## ▶ AIRCRAFT

**SUBJECT:** INSPECTION OF D-2000 SERIES MAGNETO CAPACITORS AND CAPACITOR LEAD CRIMP TERMINALS

**REASON FOR BULLETIN:** To recommend the following:

Figure 1

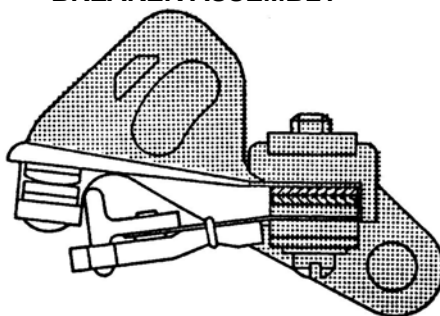
Field reports indicate that occasionally a breaker assembly will be found closed up due to melting of the cam follower directly under the breaker main spring as illustrated by figure 1, view "B" (view "A" shows normal condition of cam follower.)

Cam follower melting may be caused (1) by deterioration of the crimp joint at the capacitor lead flag terminal or (2) by a capacitor internal failure. Either of these capacitor failures causes excessive breaker point arcing. Arcing results in heating of the breaker assembly main spring thus causing the follower to melt. Parts I & II of this bulletin detail the action to be taken to prevent this occurrence and instructions to correct this condition, if it exists.

- A. In the event it is determined the nylon cam follower material is melted in the location where the cam follower contacts the breaker main spring as shown in figure 1, the breaker assembly and the associated capacitor must be replaced with new parts.

**Do not reuse a capacitor associated with a melted cam follower breaker assembly.**

Figure 2

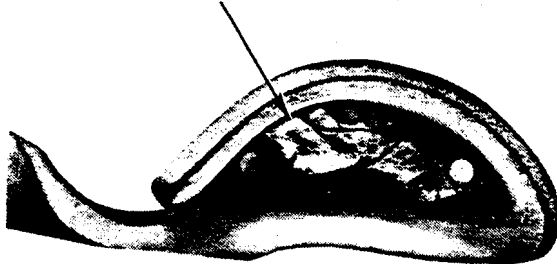
- A. Remove cover from magneto and capacitor from the cover.
- B. Visually inspect the flag terminal crimp joint for the following conditions. Inspection will be aided by using magnification, 4 power or greater.
  - 1. Examine crimp joint for evidence of a tinned wire bundle as illustrated in figure 2.

- 2. Look for evidence of a burning or an arcing appearance around the outline confinements of the wire bundle in the crimp area.
  - 3. Inspect the wire to flag terminal for evidence of conductor insulation extending within the confines of the wire crimp area. See figure 3.
- C. Corrective Action.
  - 1. If condition 1 is present, solder the conductor to the flag terminal following the soldering procedure outlined in paragraph D.

Figure 4

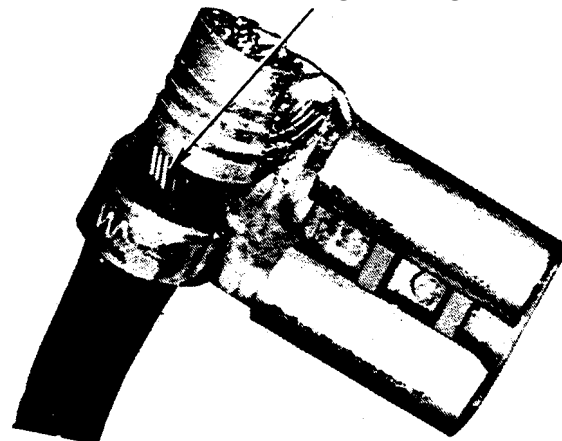
- 2. If condition 2 is discovered, replace with a new steel housing capacitor.
- 3. If condition 3 is evident, carefully attempt to move the insulation back from the crimp area to expose bare wire strands as shown in figure 4. Use a non metallic probe for this operation. If bare strands can be exposed as shown in figure 4, solder conductors to crimp area of flag terminal per soldering procedures outlined in paragraph D. If wire strands cannot be exposed and insulation appears to be caught within the conductor crimp area, replace the capacitor.

Figure 5

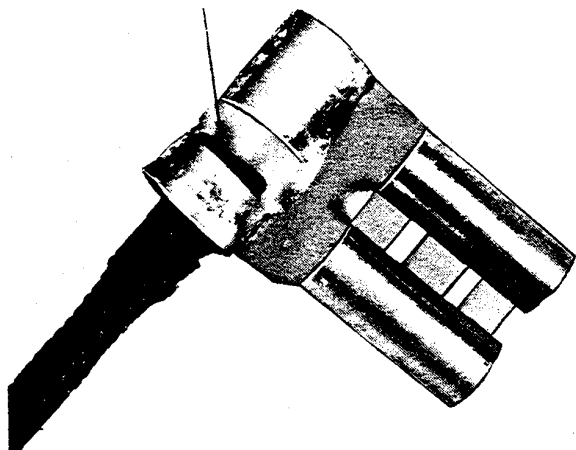
4. Apply 50/50 or 60/40 solder of the rosin core type to the heated crimp area, feeding the solder in at the open end of the crimp. Stop when molten solder appears in the area between the wire crimp and the insulation crimp. Do not use so much solder that it wicks into the wire within the insulation crimp. A properly soldered flag terminal should appear as shown in figure 5.

1. Thoroughly clean the conductor crimp area of the flag terminal. Use a stiff bristle brush and an oil free solvent such as alcohol, methylethylketone or chlorethane. Allow terminal to air dry.

2. Sparingly apply an activated liquid rosin flux to the conductor crimp area. Do not use an acid base liquid or paste flux which is corrosive in nature.

3. Using a soldering iron of 60 watt maximum rating, hold the tip firmly against the side of the flag terminal. Apply the heat under the conductor wire crimp area.

5. Thoroughly clean the completed soldered flag terminal of all flux residue with a brush and solvent as called out in step 1.

Figure 6

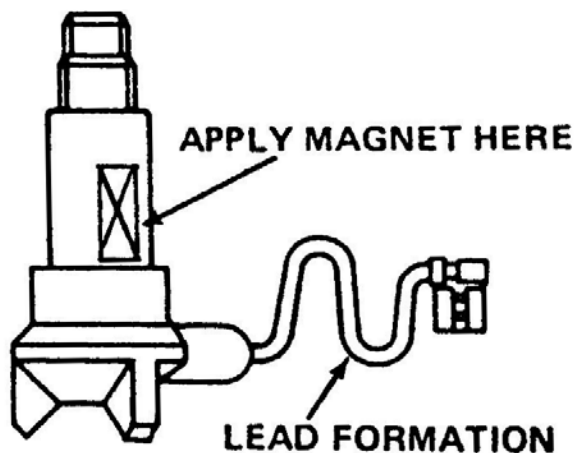
It has been discovered that some D2000 Magneto Capacitors P/N 10-382681 (6 cyl.), 10-382681-1 (8 cyl.) and 10-382807 (4 cyl.) have brass tubular housings. It is recommended that the brass housing capacitors be identified, removed from service and replaced with the steel housed capacitors. (Figure 6 illustrates the method for identifying capacitors with brass housings.)

- A. When complying with inspection requirements outlined in Part I also perform a check for housing material of the capacitor as follows:
  1. Using a small magnet, determine if the tubular housing of the capacitor is steel.
  2. Apply the magnet to the housing just above the upper edge of the rubber stabilizing boot as shown in figure 6.

1. Reinstall the capacitors in the magneto cover forming the leads as shown in figure 6. Torque the capacitor securing nuts to 60-75 inch pounds.
2. An Engine Log Book entry indicating compliance with this bulletin is recommended.

3. If the housing is not magnetic, the housing is brass and the entire capacitor should be replaced with one known to have a steel housing verified by the magnet checks described in 1 & 2 above.
4. Replacement for the brass housing capacitors can be procured through arrangements with recognized

5. After compliance with this Bulletin metal stamp the letter "S" in the lower right corner of the magneto name plate and also make an appropriate Engine Log Book entry.
